ORIGINATION FORM -

Proposed Revisions to a Standard Plans Index (Please provide all information — Incomplete forms will be returned)

Index Number: 641-010 Sheet Number (s): All

Index Title: Concrete Poles

NEW SHEET 5 SERVICE POLE - TYPE 11D (16 Ft.)

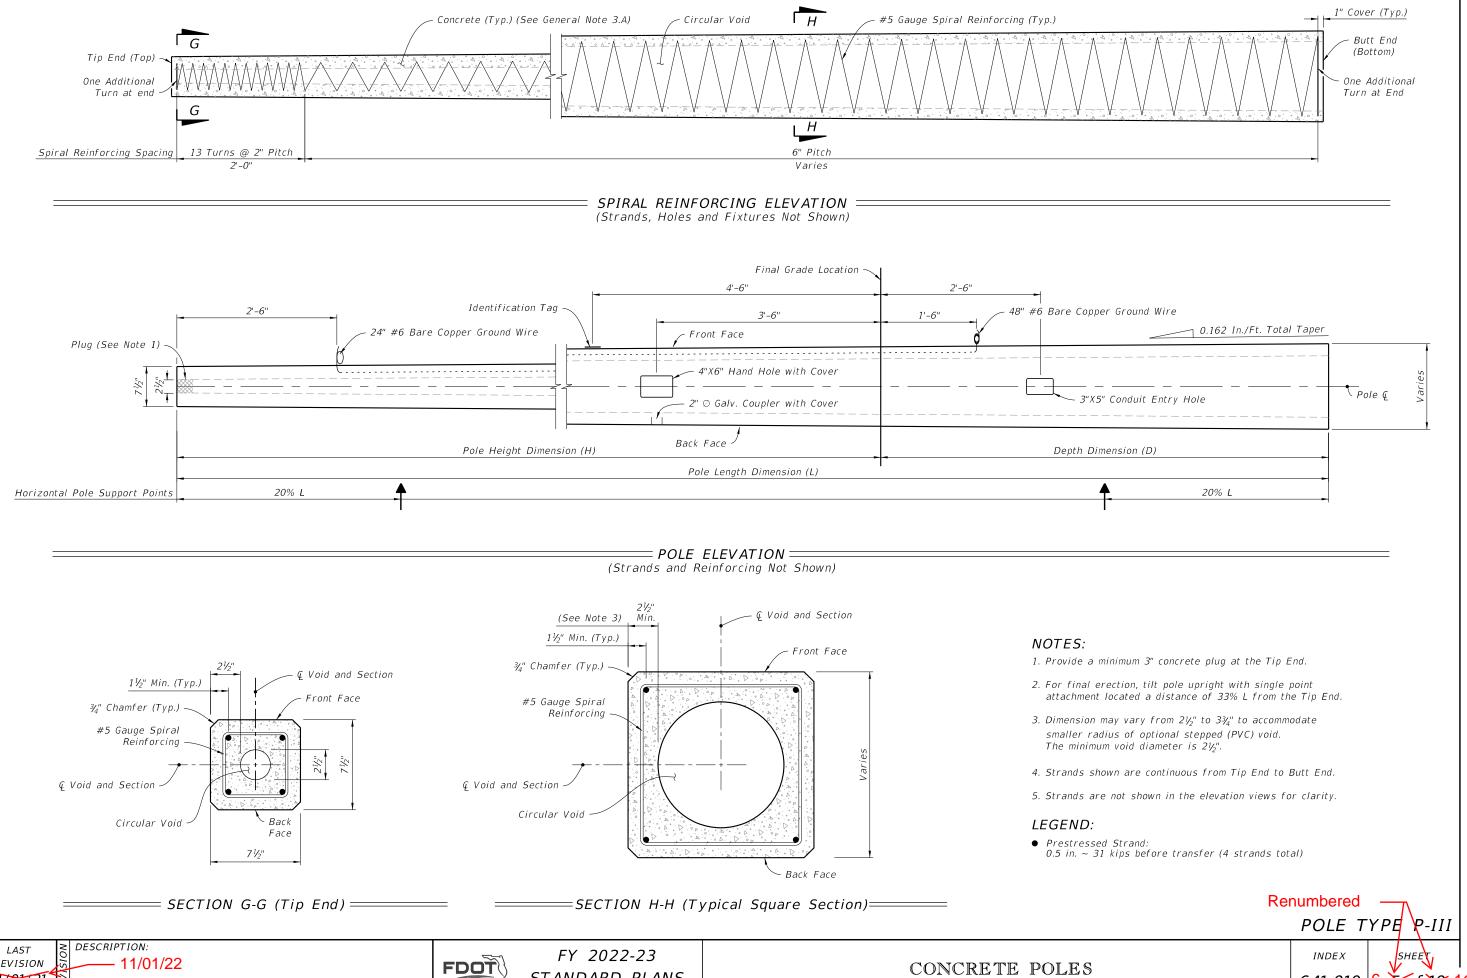
Sheet 1: Change Note 3.A reference to Class V Special to Class V. Sheet 5: Added new sheet for a new 16 ft pole version P-IID.

SERVICE POLE TYPE P-IID (16 Ft.)

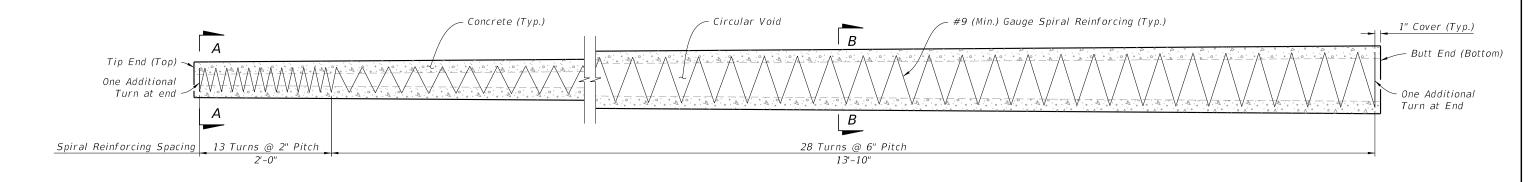
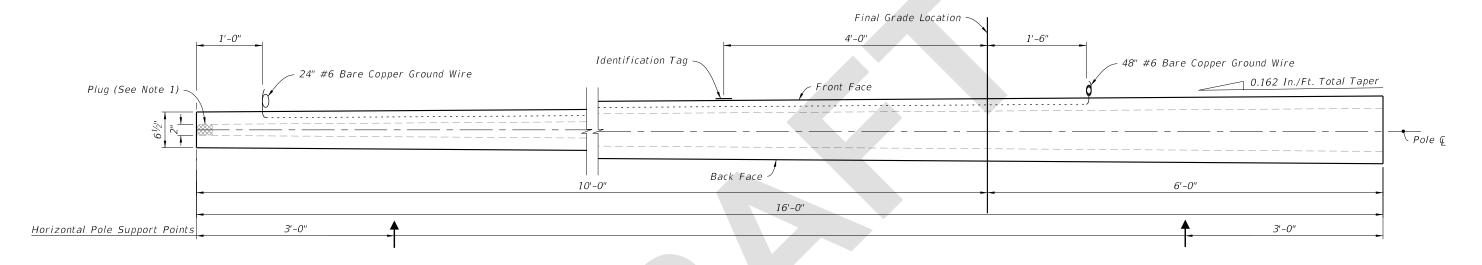
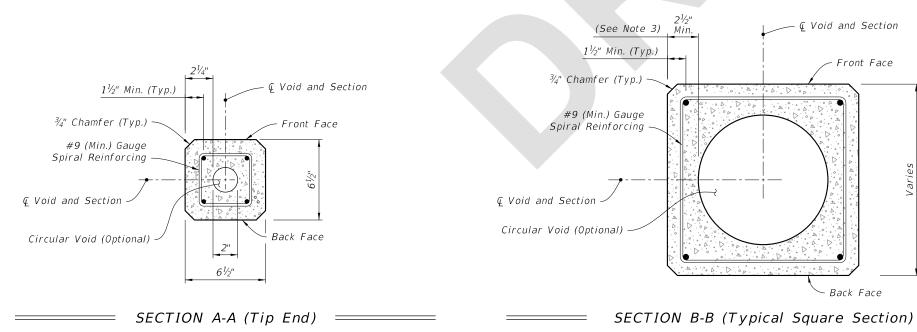
This 16-foot pole was requested by Districts to accommodate project-specific service point designs. Electrical service point details for a 16-foot pole are under consideration for a future Standard Plans publication.

- 1. Provide a minimum 3" concrete plug at the Tip End.
- 2. For final erection, tilt pole upright with single point attachment located a distance of 5 feet from the Tip End.
- 3. Dimension may vary from $2\frac{1}{4}$ " to $3\frac{1}{2}$ " to accommodate smaller radius of optional stepped (PVC) void. The minimum void diameter is 2".
- 4. Strands shown are continuous from Tip End to Butt End.
- 5. Strands are not shown in the elevation views for clarity.
